STAFF REPORT

SUBJECT: FP-2021-0048
Edington Commons No. 2

Final plat consisting of 46 buildable lots and 9 common lots on 5.75 acres of land in the R-15 zoning district.

B. Final Plat (dated: 8/16/21)

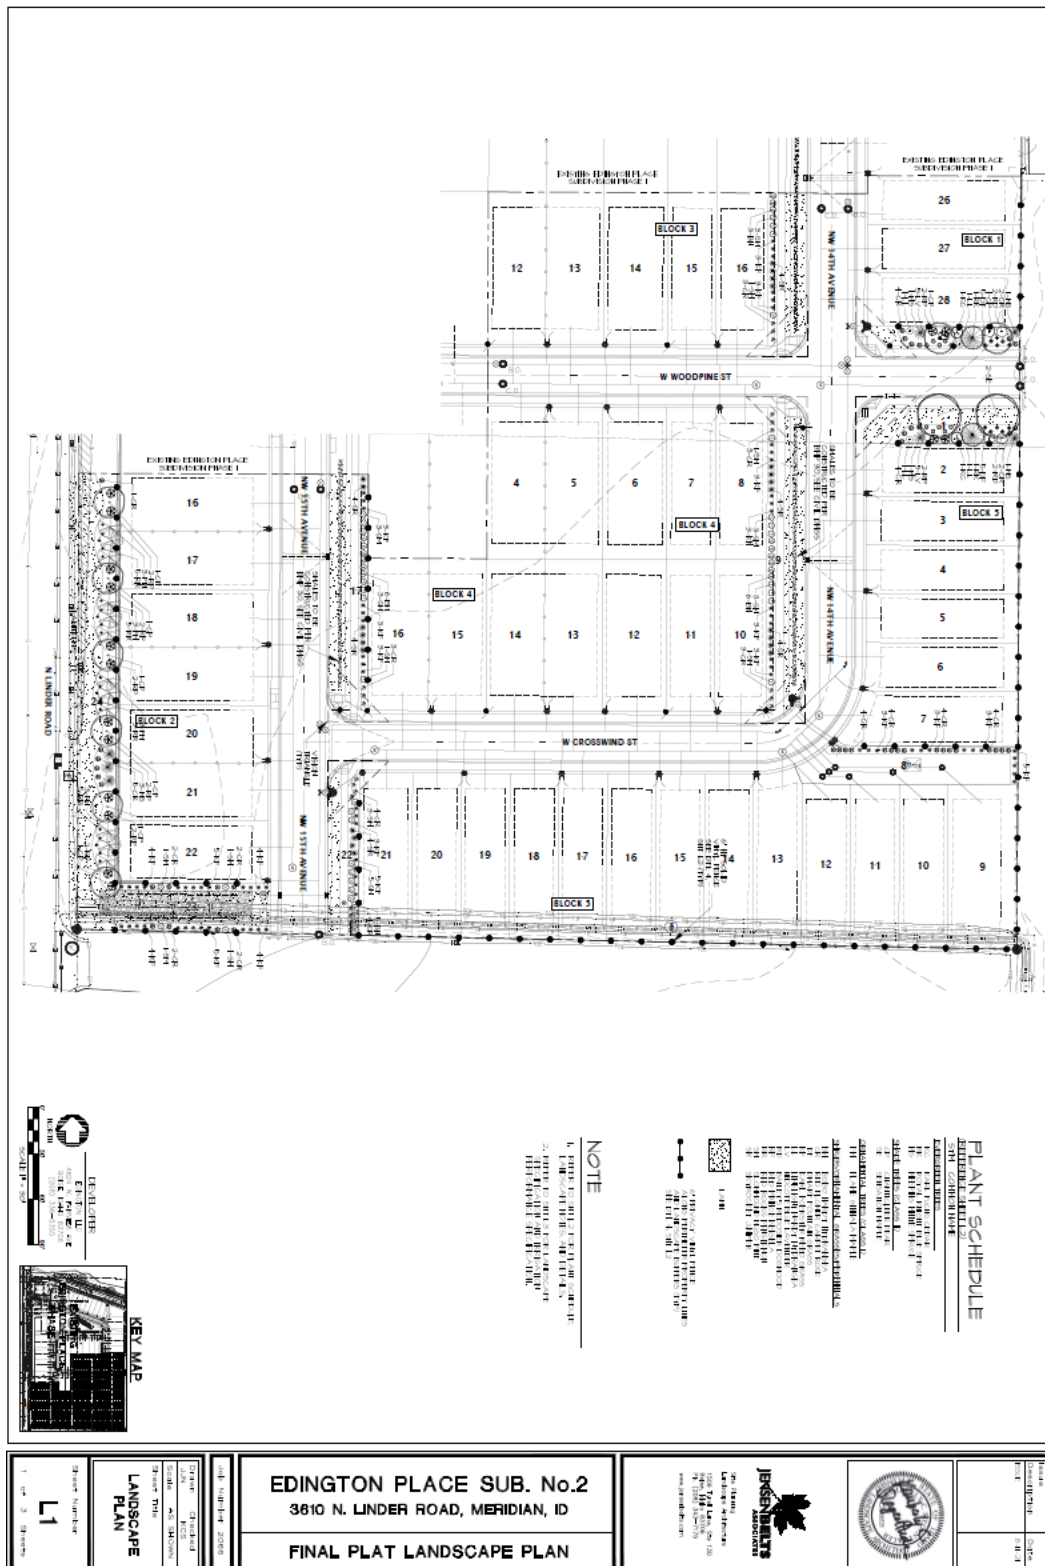
1. Applicant shall meet all terms of the approved annexation (Development Agreement - Inst. #2020-044056) and preliminary plat (H-2019-0109) applications approved for this site.
2. The applicant shall obtain the City Engineer's signature on the subject final plat within two years of the City Engineer's signature on the previous phase final plat (by July 15, 2023); or apply for a time extension, in accord with UDC 11-6B-7.
3. Prior to submittal for the City Engineer's signature, have the Certificate of Owners and the accompanying acknowledgement signed and notarized.
4. The final plat prepared by Sawtooth Land Surveying, LLC, stamped by Kevin M. Borah, dated: 8/16/2021, included in Section V.B shall be revised as follows:

Plat Notes:

- a. Note #7: Include the recorded instrument number of the ACHD license agreement.
- b. Note #8: Include in the note that the lot is encompassed by a perpetual ingress/egress easement benefitting Lots 9-12, Block 5.
- c. Note #13: Include the recorded instrument number of the ACHD sidewalk easement.
- d. Note #15: Correct plural references to the common driveway (there is only one).

Legend:

- e. Include recorded instrument number of the ACHD sidewalk easement.

A copy of the revised plat shall be submitted for City Engineer signature.

C. Landscape Plan (dated: 8/14/2020)

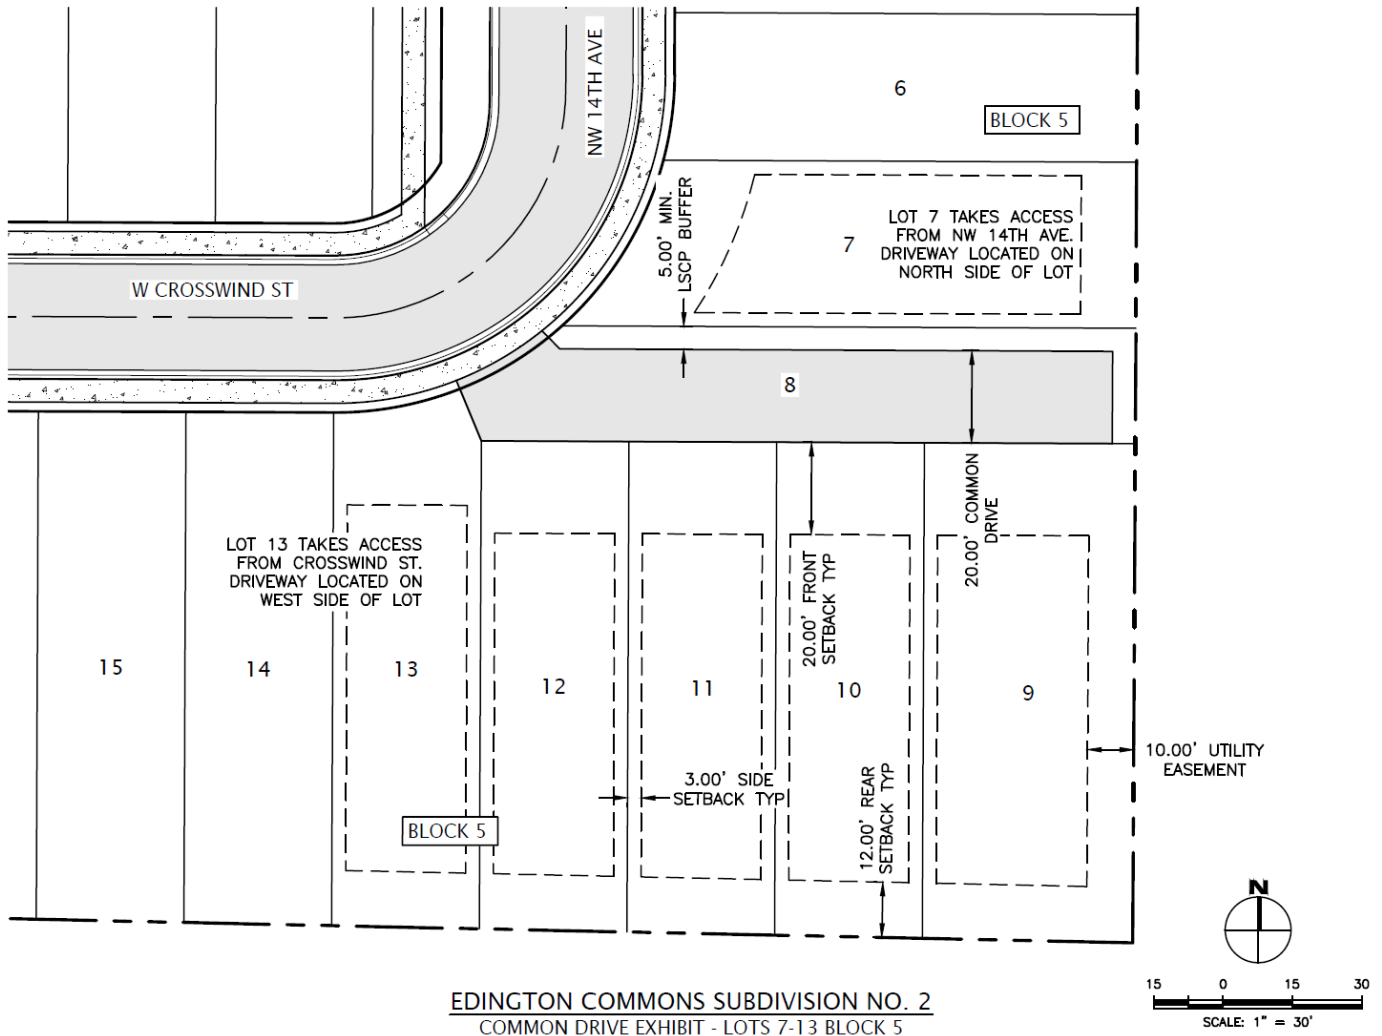
5. The landscape plan prepared by Jensen Belts Assoc., dated 08/14/2020, included in Section V.C, shall be revised as follows:
 - a. Include the linear feet of parkways and required & provided trees in the calculations table on Sheet L2 of the landscape plan that demonstrate compliance with the standards listed in UDC 11-3B-7C.

- b. Include landscaping adjacent to the pathway on Lot 23, Block 2 in accord with the standards listed in UDC 11-3B-12C per preliminary plat condition #3f. *If trees aren't allowed within the drainage easement, the lot should be widened a minimum of 5 feet to accommodate the required trees and shrubs.*

D. Common Driveway Exhibit

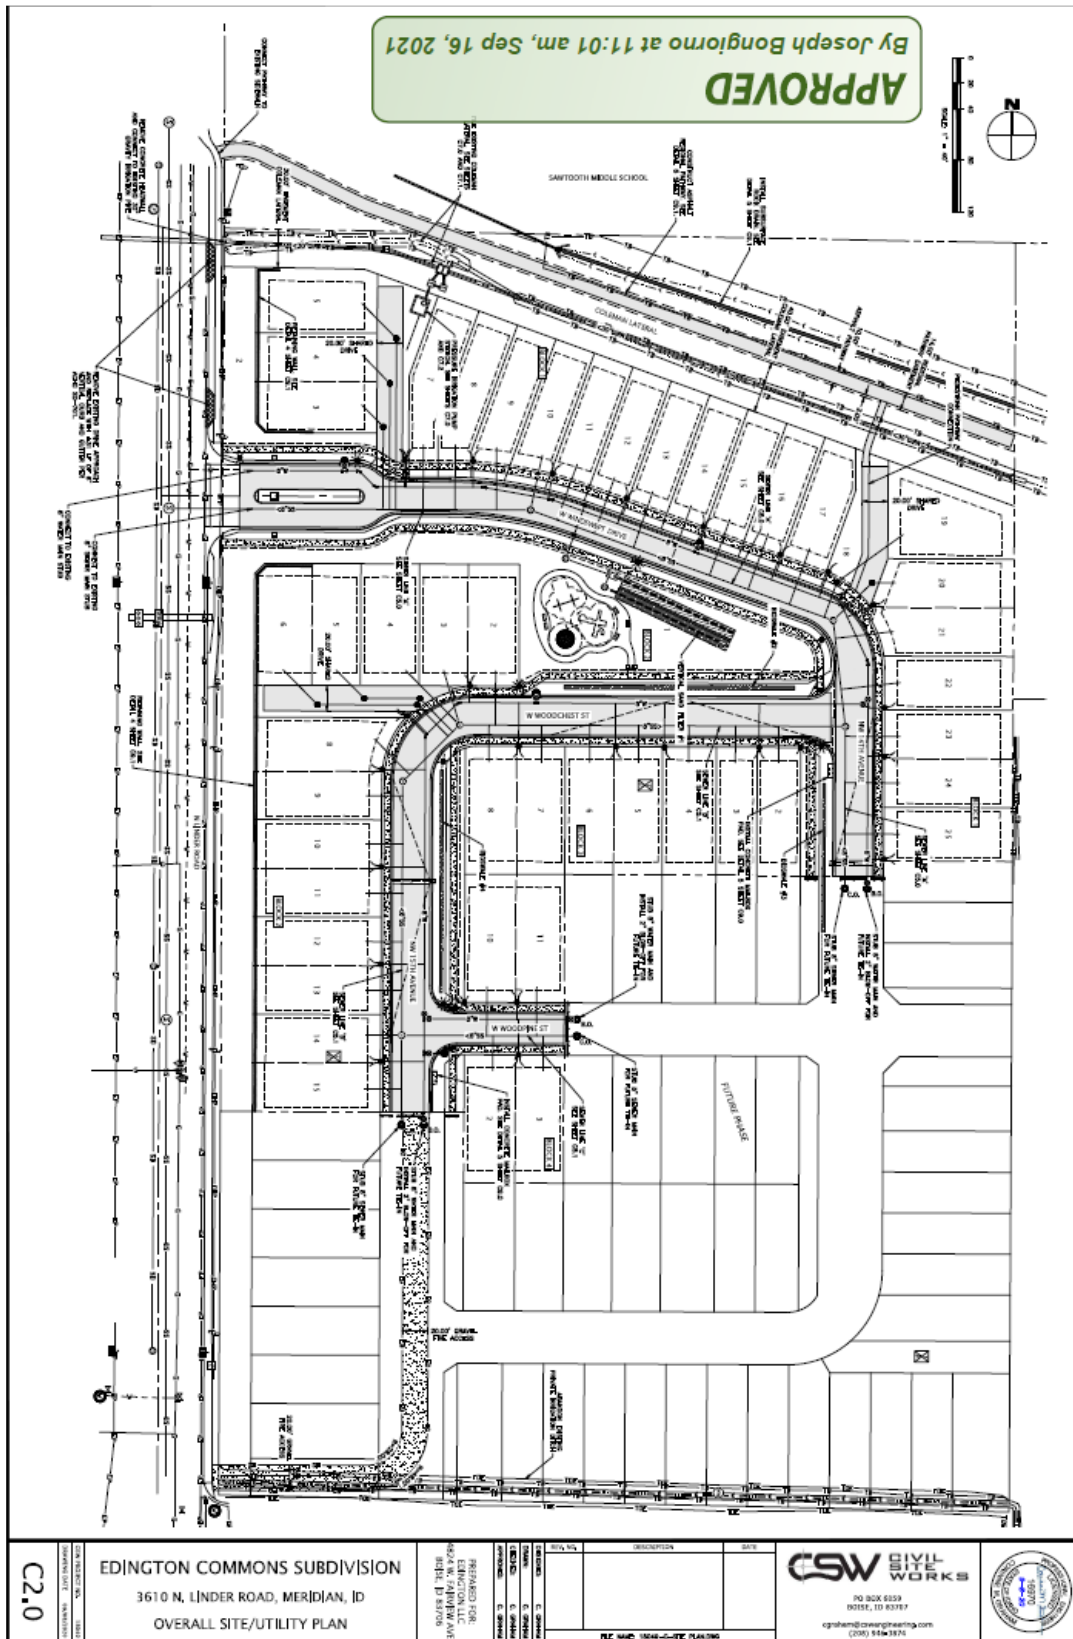
6. Construction of the common driveway on Lot 8, Block 5 shall comply with the standards listed in UDC 11-6C-3D. The lots accessed via the common driveway (i.e. Lots 9-12, Block 5) shall have setbacks consistent with that shown on the exhibit in Section V.D.
